**UNITED STATES
NUCLEAR REGULATORY COMMISSION**
WASHINGTON, D.C. 20555-0001

SUBJECT: COLUMBIA GENERATING STATION - STAFF ASSESSMENT OF
INFORMATION PROVIDED UNDER TITLE 10 OF THE *CODE OF FEDERAL
REGULATIONS* PART 50, SECTION 50.54(f), SEISMIC HAZARD
REEVALUATIONS FOR RECOMMENDATION 2.1 OF THE NEAR-TERM TASK
FORCE REVIEW OF INSIGHTS FROM THE FUKUSHIMA DAI-ICHI ACCIDENT
(CAC NO. MF5274)

STAFF ASSESSMENT BY THE OFFICE OF NUCLEAR REACTOR REGULATION

COLUMBIA GENERATING STATION

Figure 3.4-4. Licensee's sensitivity analysis of GMRS to minimum spectral amplification values, copied from Figure 4 in Swank (2015b).

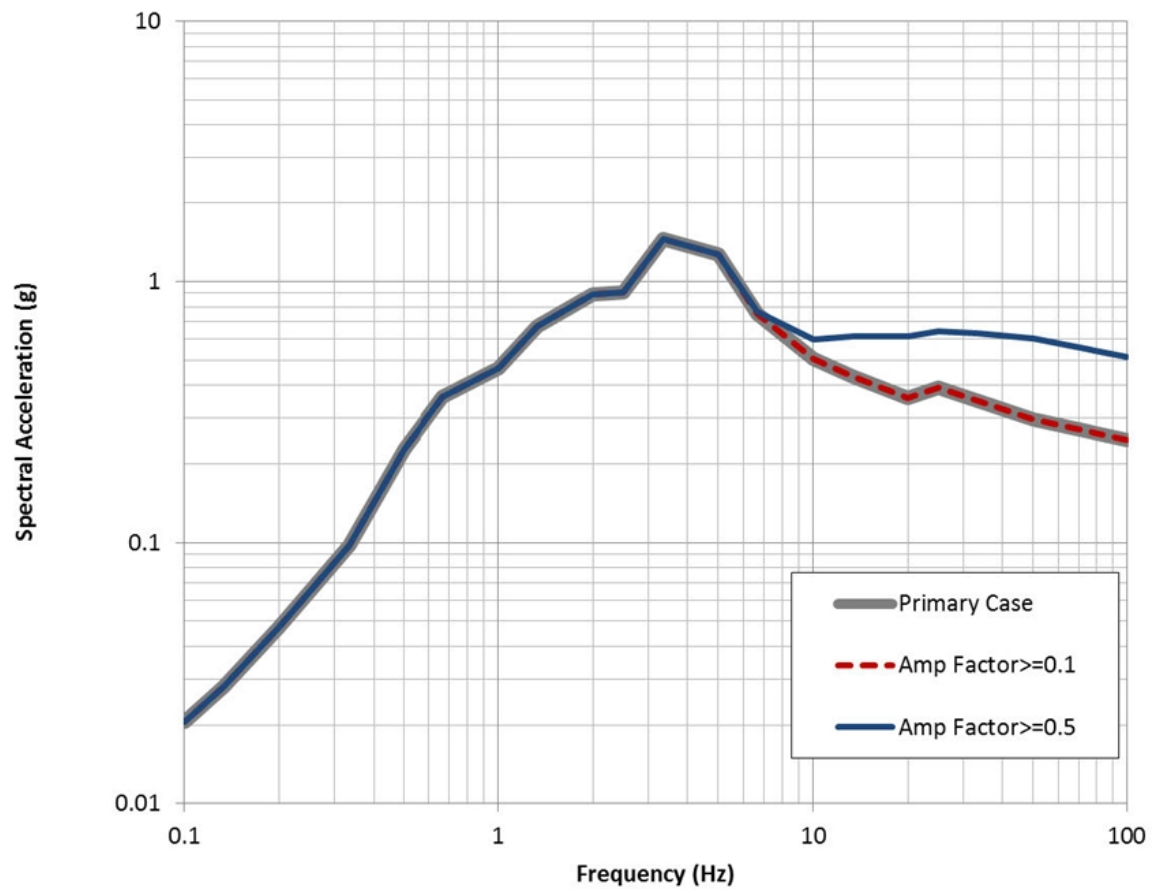
In an RAI to the licensee, the NRC staff asked the licensee to justify its decision to not implement the minimum amplification factor of 0.5, as recommended in the SPID (EPRI, 2012). In its response (Swank, 2015b), the licensee stated that amplification factors less than 0.5 have been reported by other analysts using both equivalent linear and nonlinear methods. To demonstrate the impact of not using a minimum value of 0.5, the licensee performed a sensitivity analysis with minimum amplification factors set to 0.1 and 0.5. As shown in Figure 3.4-4 of this staff assessment, the results of the licensee's analysis showed that the GMRS in the frequency range of 1 Hz to 10 Hz is insensitive to the minimum amplification factor but that the higher frequencies are moderately impacted. Based on its confirmatory site response analyses, the NRC staff concludes that the combination of (1) the impedance contrast between the interbed and basalt layers; and (2) the material damping of the interbeds, results in the low amplification factors for the higher spectral frequencies. Because these two factors are actual physical characteristics of the Saddle Mountain Basalts, the staff concludes that limiting the site amplification factors to a minimum value of 0.5 is not necessary for this site. Therefore, the NRC staff concludes that the licensee's decision to not use the minimum value of 0.5 is appropriate for the CGS site.
